A4LD UPDATE HANDBOOK INDEX

FORD A4LD

"UPDATE HANDBOOK"

Figure 5

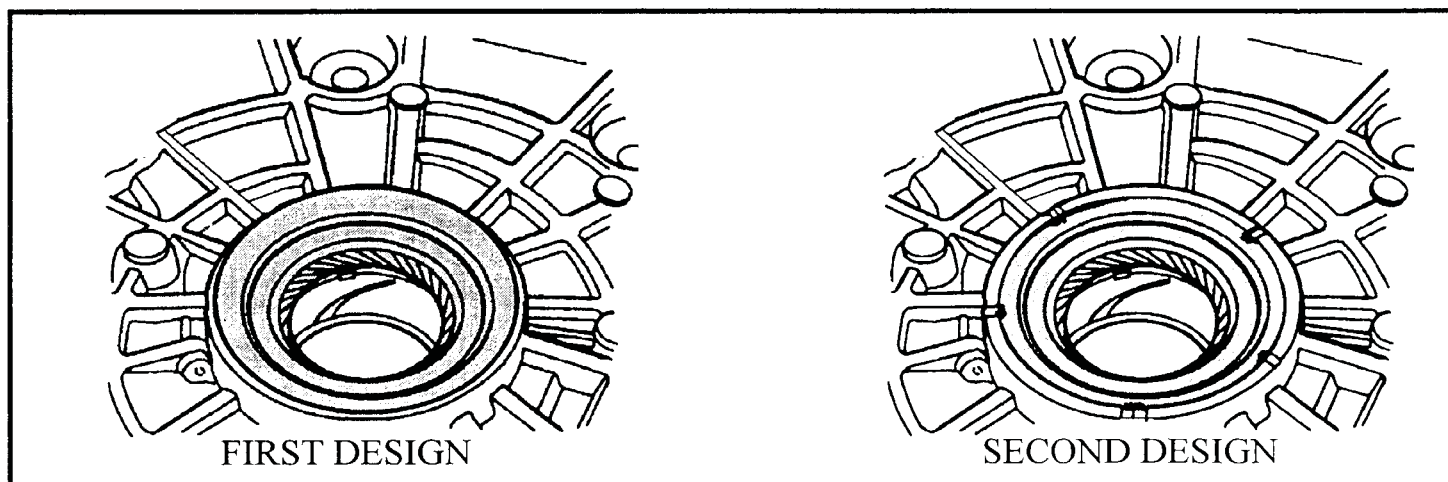
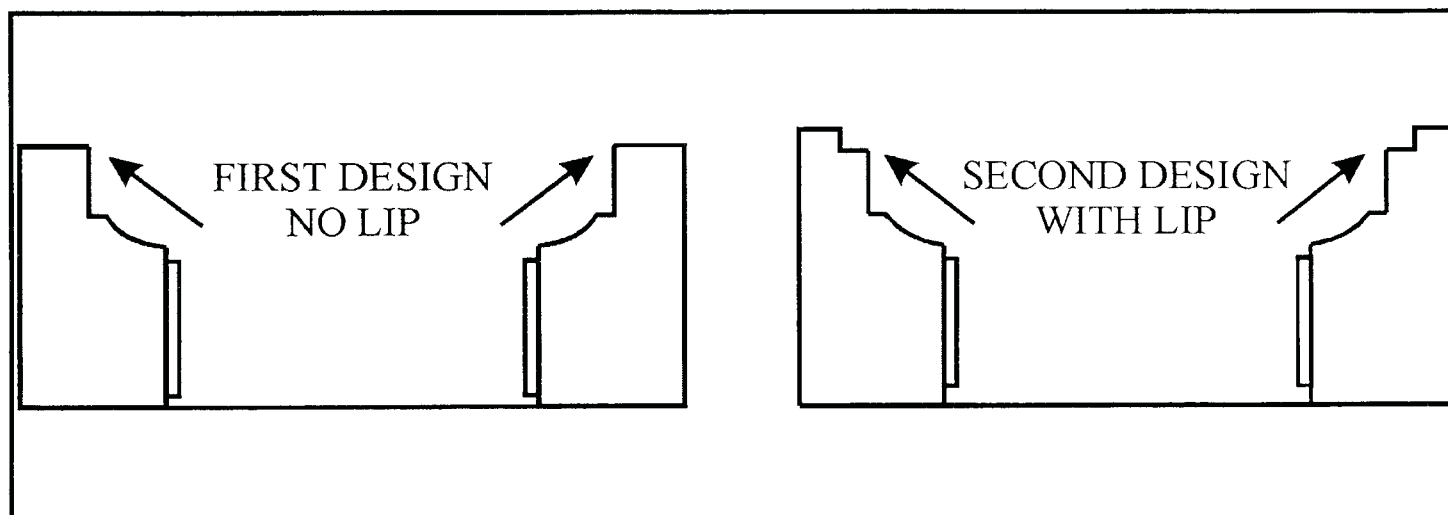
CHANGE #1: A .105" machined lip was added at the front seal bore to allow the front seal to be staked into place.

BELL HOUSING - A machined lip was added at the front seal bore to allow the front seal to be staked in place (Refer to Figures 5 & 6).

Figure 12

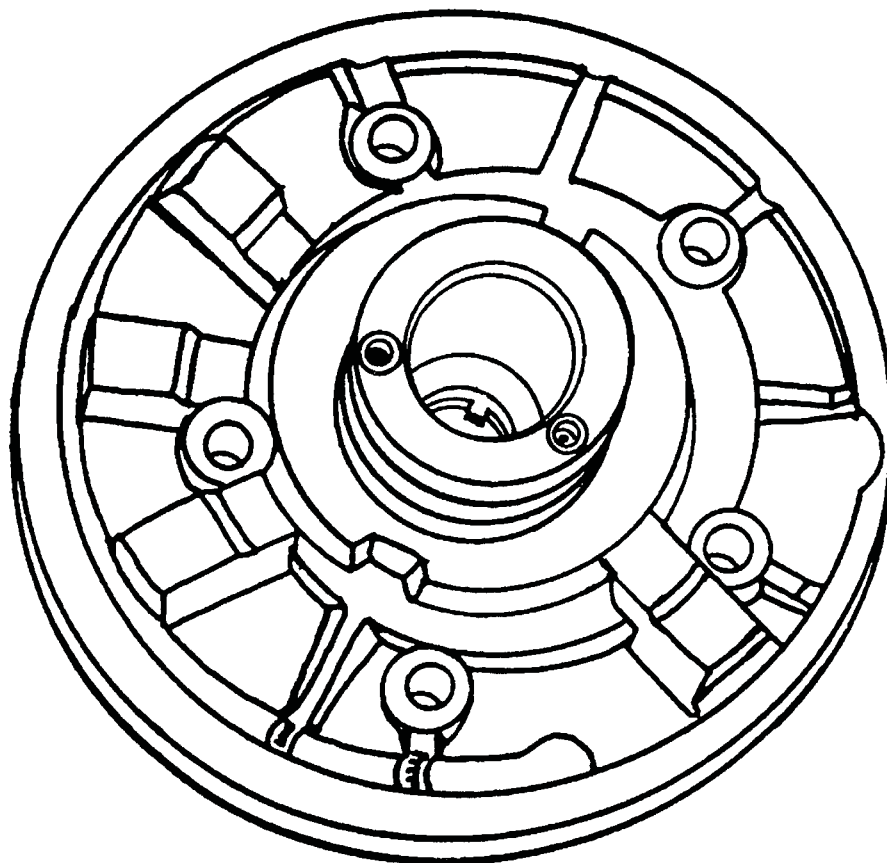
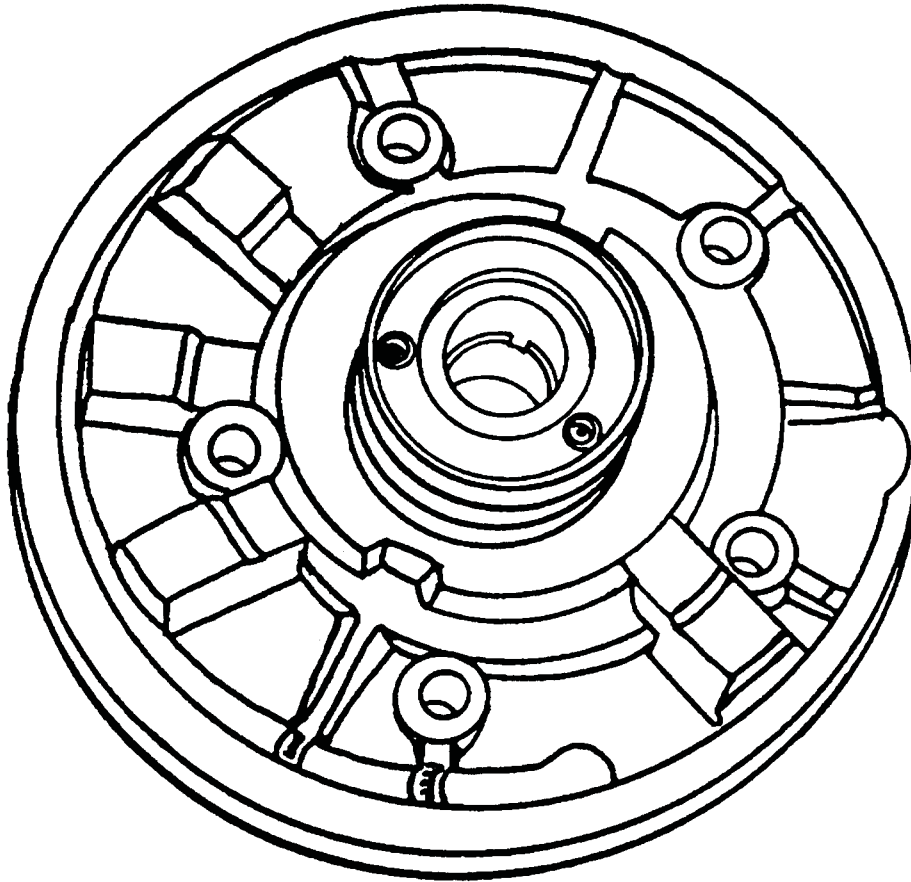
CHANGE: The rear input shaft bushing location was moved closer to the top of the stator.

STATOR SUPPORT - The stator support wall was made thicker to accomodate the change in the bushing location (See Figures 12 and 13).

The early and late design pumps are interchangeable. However, all late design pumps will have the larger pump bolt holes. The late design pump bolt requires a late design pump plate and late design bellhousing.

Figure 22

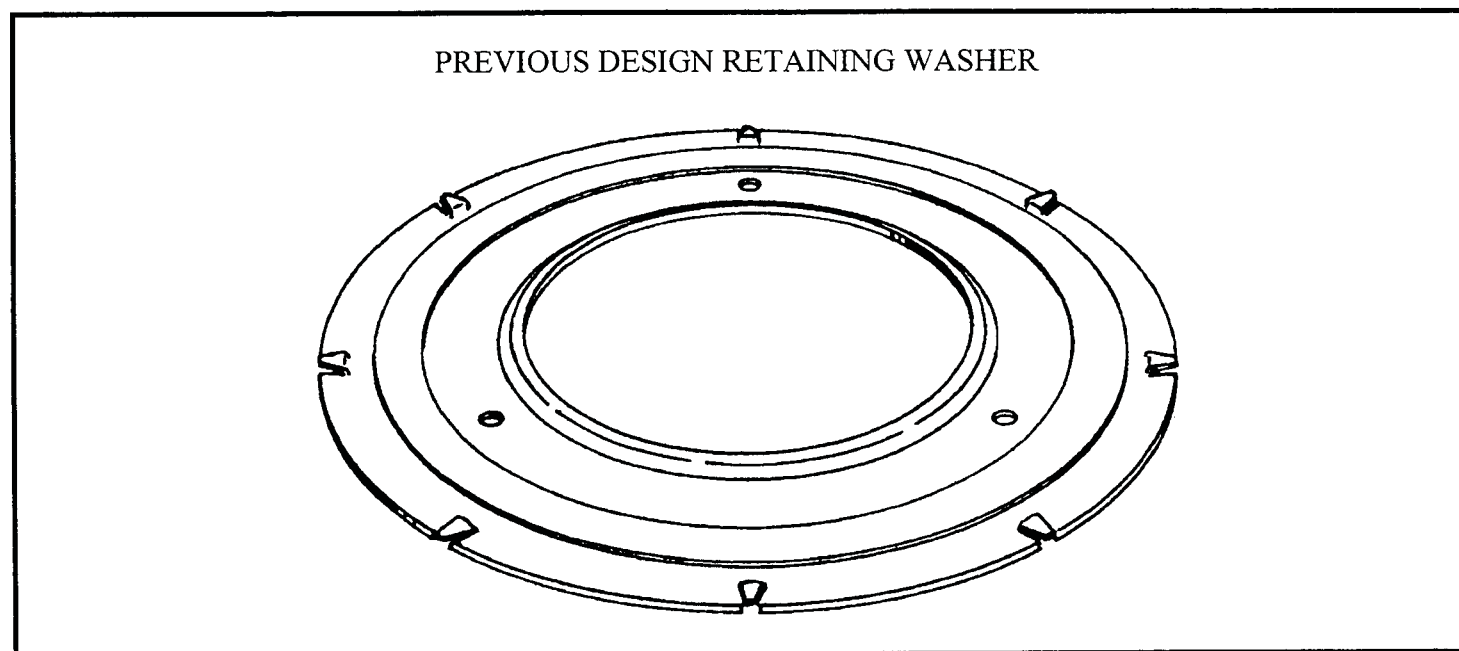
CHANGE: Vehicles equipped with A4LD transmissions built after June 9, 1992 contain a plastic caged overdrive sprag assembly that is no longer serviced. The previous design steel caged sprag and all related parts must be used for service (See Figure 24).

- (1) OVERDRIVE SPRAG ASSEMBLY - Previous design steel caged sprag must be used, as the plastic caged sprag is no longer serviced, which requires the use of the previous design ring gear and the previous retaining washer (See Figure 22).
- (2) OVERDRIVE RING GEAR - Previous design ring gear must be used to accommodate the steel caged sprag and retaining washer that must be used. Measure the overdrive ring gear, as shown in Figure 23, to ensure you have the proper one.
- (3) RETAINING WASHER - Previous design retaining washer shown in Figure 22 must be used to accommodate the previous design overdrive ring gear.

Overdrive Sprag Assembly (Previous Design)	E5TZ-7A089-A
Overdrive Ring Gear (Previous Design)	E5TZ-7A153-A
Retaining Washer (Previous Design)	E7TZ-7L339-A

Figure 23

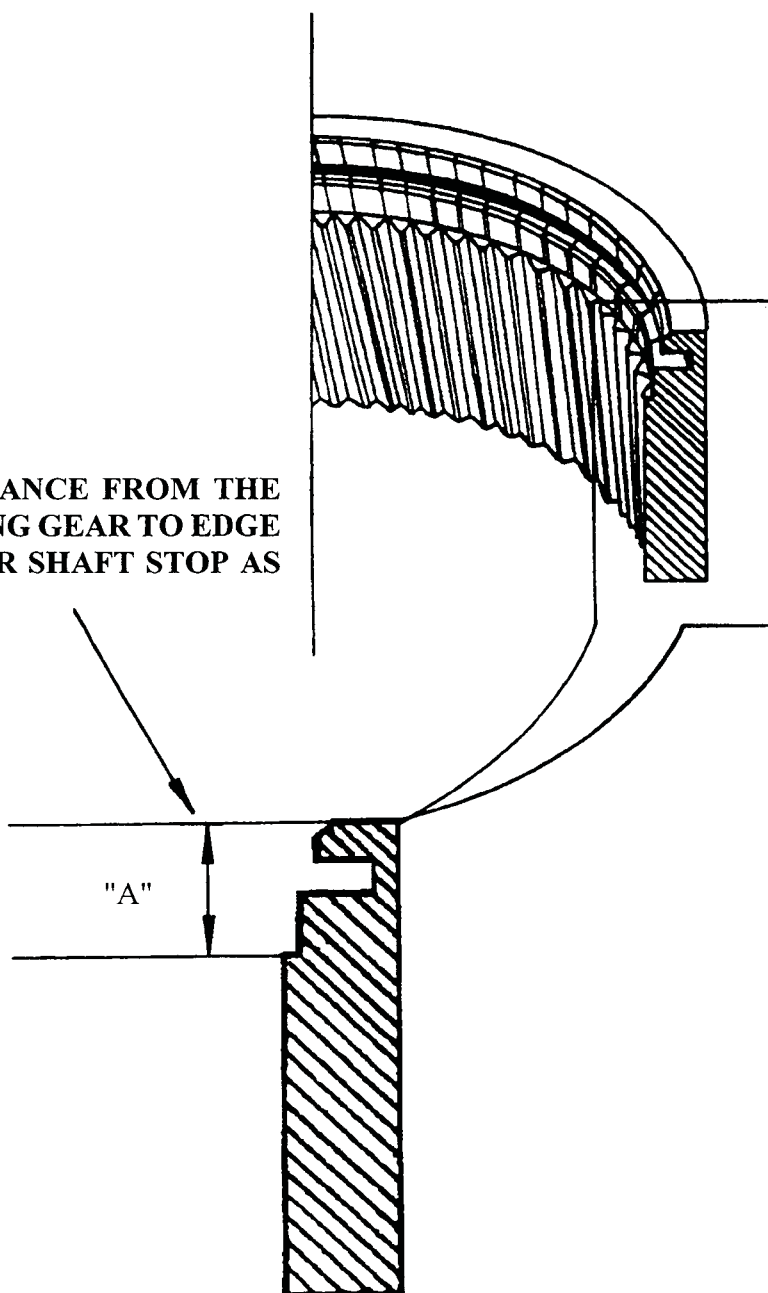
MEASURE DISTANCE FROM THE TOP OF THE RING GEAR TO EDGE OF THE CENTER SHAFT STOP AS SHOWN HERE

PREVIOUS DESIGN WITH STEEL CAGED SPRAG, "A" = .335"
DESIGN LEVEL WITH PLASTIC CAGED SPRAG, "A" = .295"

Figure 25

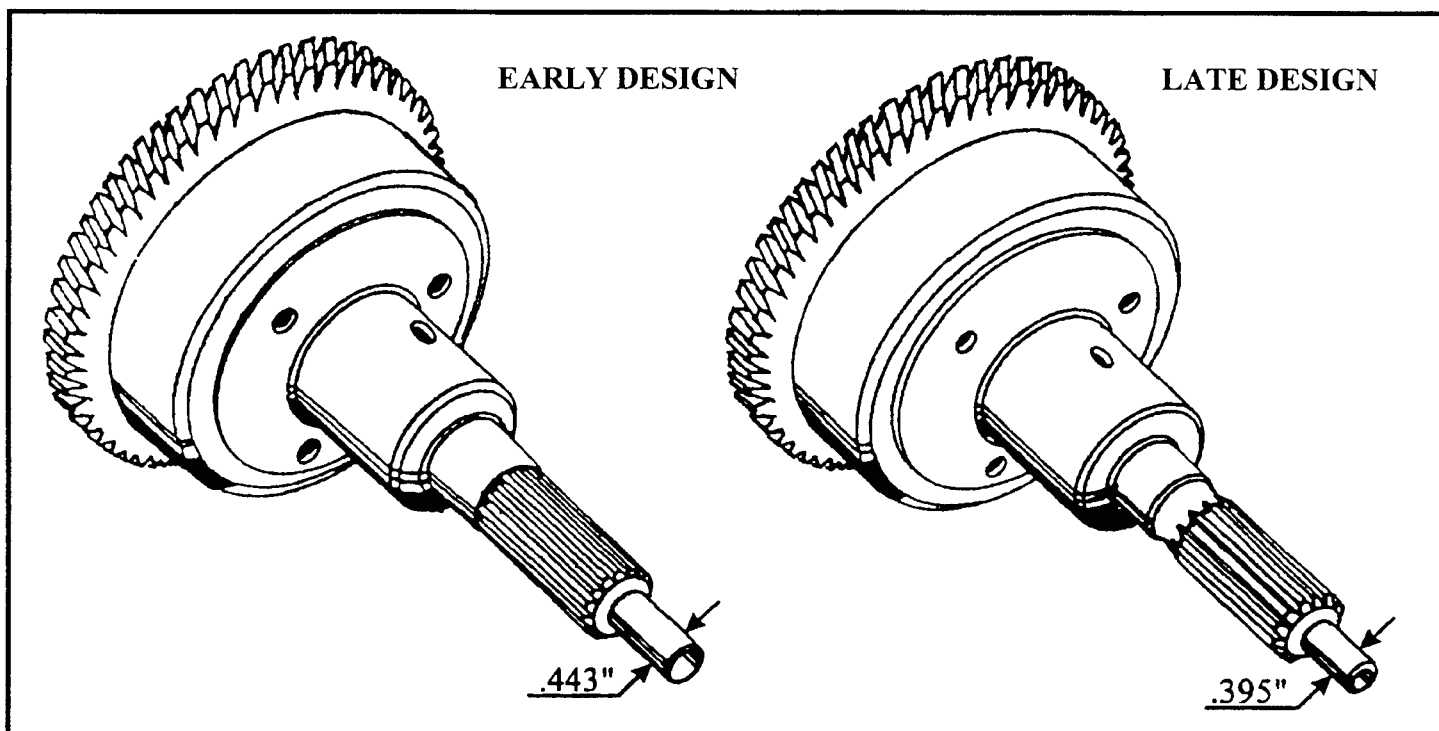
CHANGE: Beginning in model year 1990, on 4.0L models, the O.D. center shaft pilot was machined .048" smaller in diameter.

- (1) O.D. CENTER SHAFT - The diameter of the pilot on the shaft was machined .048" smaller than the previous design, to accommodate the bearing added to the output shaft. The new design pilot diameter is .395", and the previous design pilot diameter is .443". (See Figure 25)
- (2) OUTPUT SHAFT - Previous design bushing was replaced by a caged needle bearing. (See Figure 26). The caged needle bearing is not serviced separately from Ford Motor Co.

Figure 27

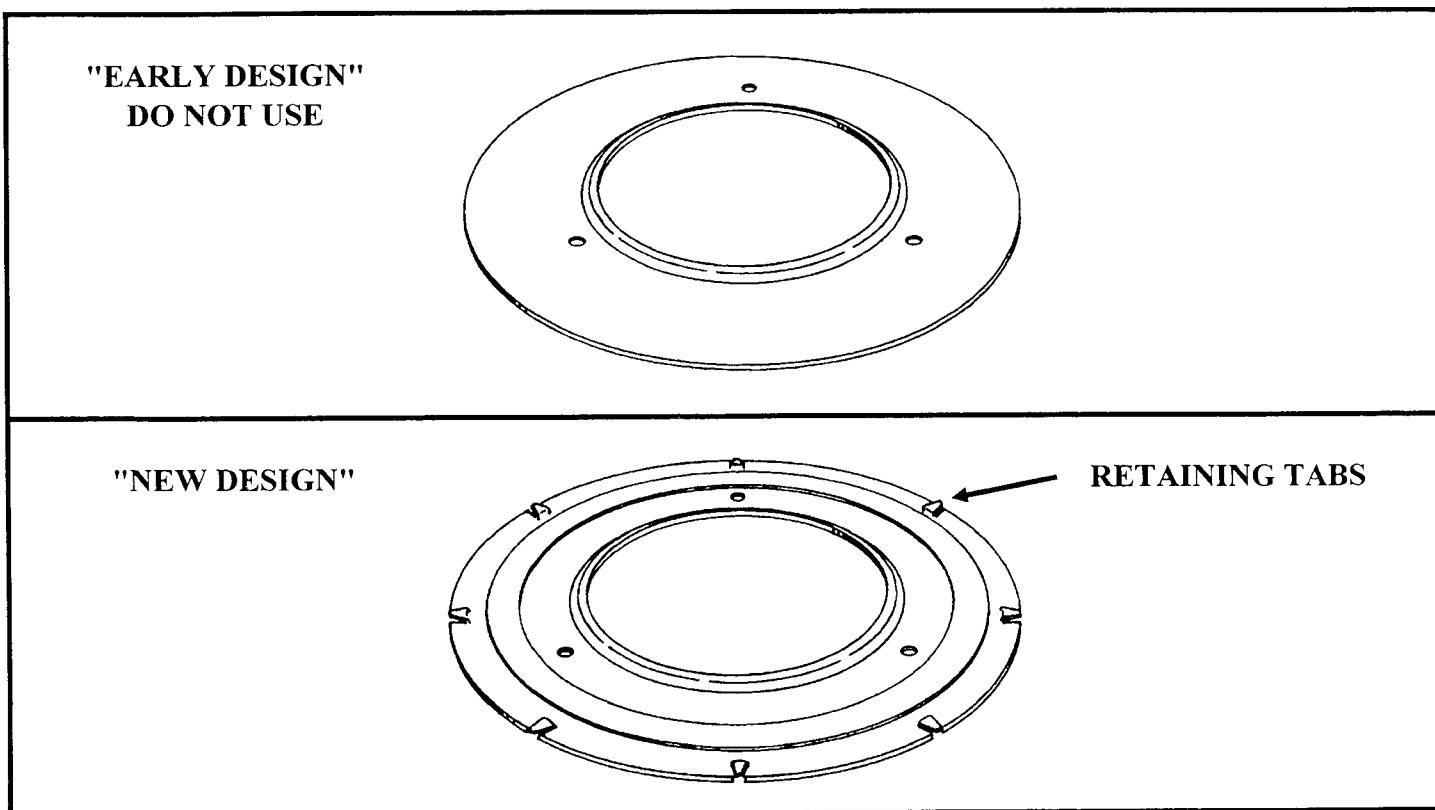
CHANGE: The overdrive sprag retaining washer was changed, sometime in model year 1987, in vehicles equipped with A4LD transmissions.

- (1) OVERDRIVE SPRAG RETAINING WASHER - The new design retaining washer increased in overall diameter and has retaining tabs stamped into it to prevent the washer from rotating in the overdrive ring gear. (See Figure 27).

Retaining Washer (New Design).....E7TZ-7L339-A

Figure 29

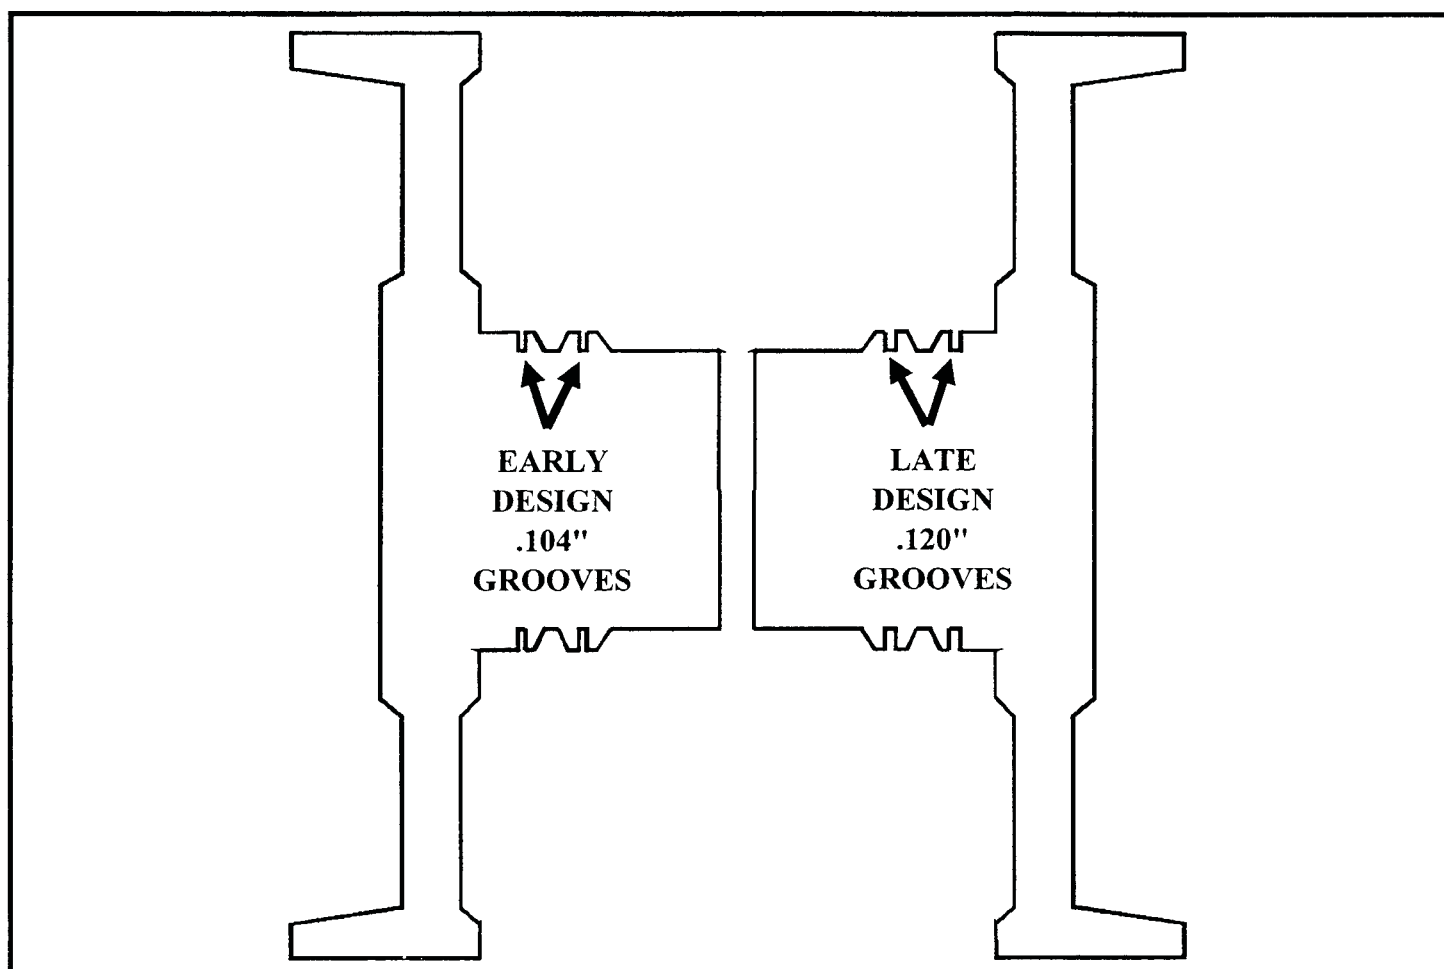
CHANGE: Sealing ring grooves were widened from .104" to .120", and the OEM part number did not change.

(1) **CENTER SUPPORT** - The sealing ring grooves were widened from .104" to .120"
(See Figure 29).

The center supports are interchangeable, however, you must use the correct size rings for the center support you are using.

Figure 33

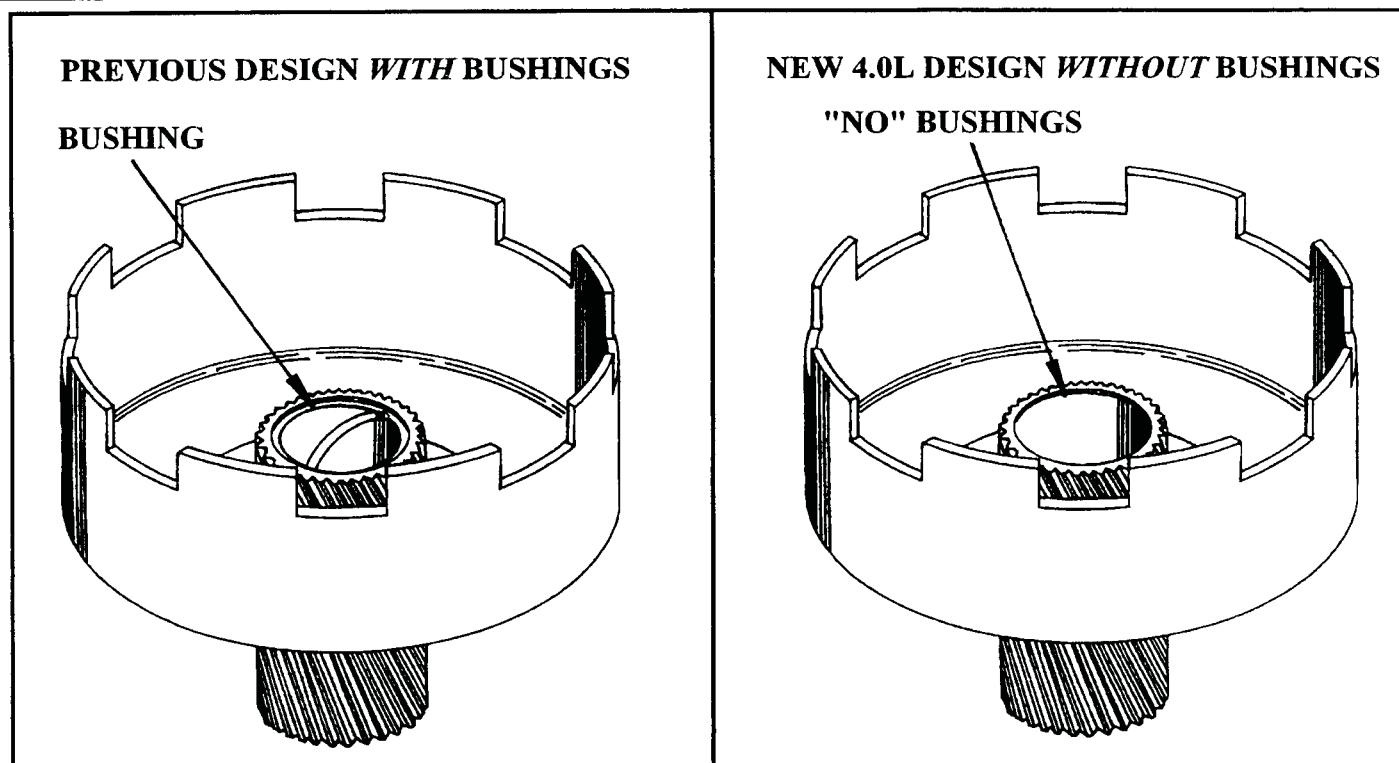
(2) **SUN GEAR** - Both bushings, inside the sun gear, were eliminated to allow full lubrication flow to the front planetary (See Figure 33).

- (1) The new design sun gear **WITHOUT** bushings **WILL** retro-fit back to all previous models (See Figure 33).
- (2) The previous design sun gear **WITH** the bushings **CANNOT** be used forward into the 4.0L models (See Figure 33).
